10/814,877

Jack E. Caveney

Office Action Summary

- 1) ☒ Responsive to communication(s) filed on 11 April 2007.
- 2a) ☒ This action is **FINAL**. 2b) ☐ This action is non-final.
- 3) ☐ Since this application is in condition for allowance except for formal matters, prosecution as to the merits is closed in accordance with the practice under *Ex parte Quayle*, 1935 C.D. 11, 453 O.G. 213.

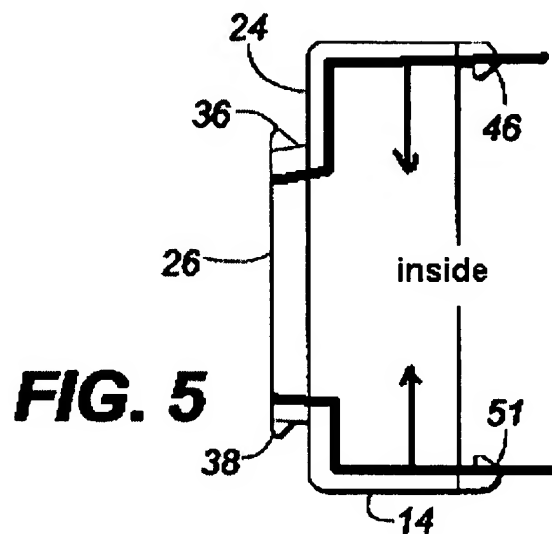
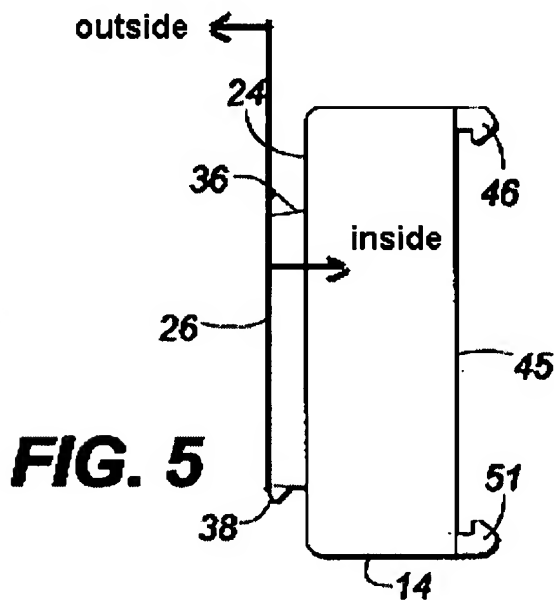
In response to Applicant's argument that Sanchez does not disclose "a faceplate having a plurality of mounting openings and each mounting opening having at least one modular jack retention latch protruding within the mounting opening", please note that element 44 is a retention latch, and protrudes within mounting opening 32. Please note that the mounting opening is not limited to that portion in the front of the jack holder, but it extends backwards from the front face. Additionally, the fact that portion 44 is not part of the jack holder does not preclude it from being a retention latch. Element 44 protrudes within the mounting opening (see following figure).

Additionally, element 44 retains the modular jack to the faceplate 14, thus it is a modular jack retention latch.
